SERVICE INFORMATION BULLETIN

APPLICABILITY: 2017MY Legacy and Outback Models SUBJECT: New Disc Brake Mounting Bolt and Torque Specification Change

NUMBER: 06-57-16 DATE: 07/28/16

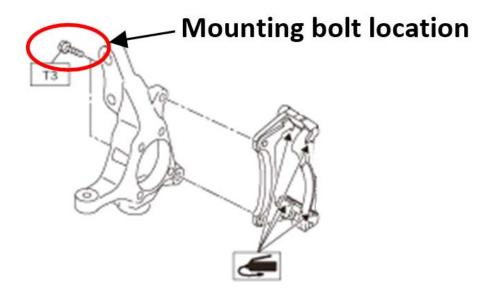
This Service Information bulletin announces a change to the mounting bolts and corresponding increased tightening torque value used for securing the front disc brake caliper support to the axle housing.

The new mounting bolts with an integral washer were incorporated at the **2017MY start of production** (SOP).

(NEW)

with Washer

(OLD)

NO Washer

The part number for the new mounting bolt is 901260023.

The illustration below shows the location of the mounting bolts. The (increased) torque specification for the new mounting bolt (T3) is 135 Nm (99.6 ft. lbs.).
